Changes to the external appearance of the lower terminal block cover of MELSEC-F FX3S series main unit

August 2019

MELSEC-F FX3S series

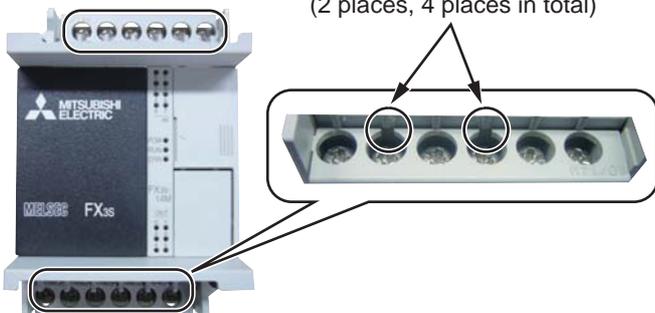
The external appearance of the lower terminal block cover of the FX3S series main unit is changed as below.

Changed Items: Lower terminal block cover of the FX3S series main unit	
Before change	
After change	<p>Notches are added. (2 places, 4 places in total)</p>
